Legacy OTA extra characterization | TT / 1.8 V / 27 C
Returned data reviewed; full original acceptance remains incomplete

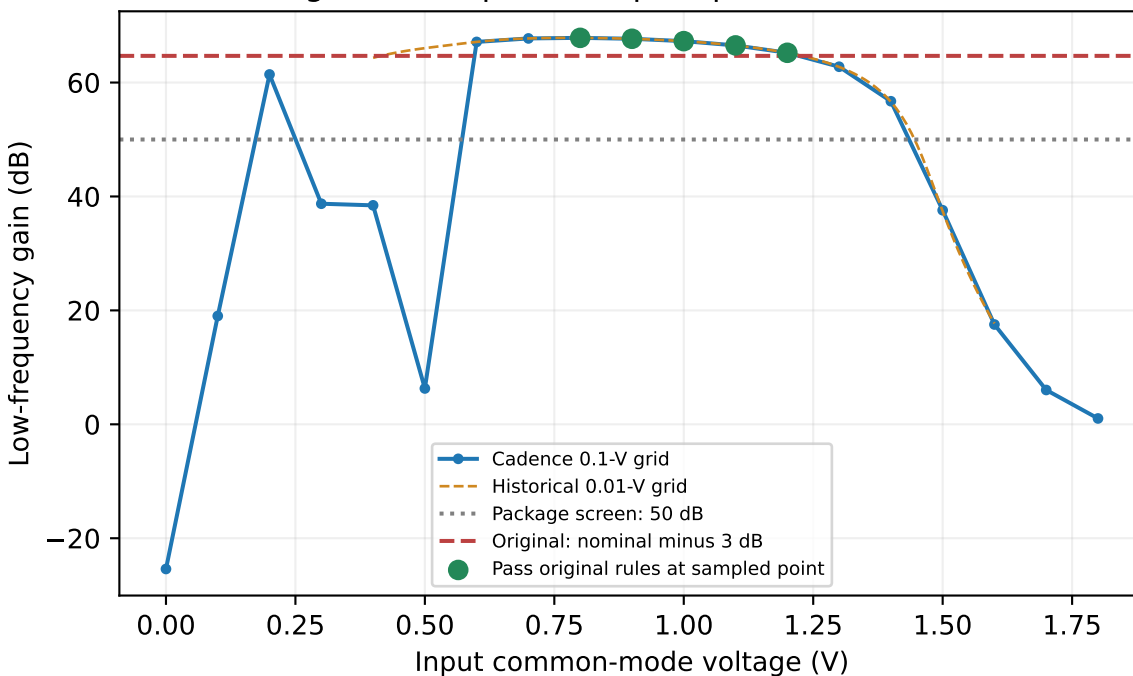
10 pF and 20 pF fail the margin limit

All four steps settle; margin is a separate requirement
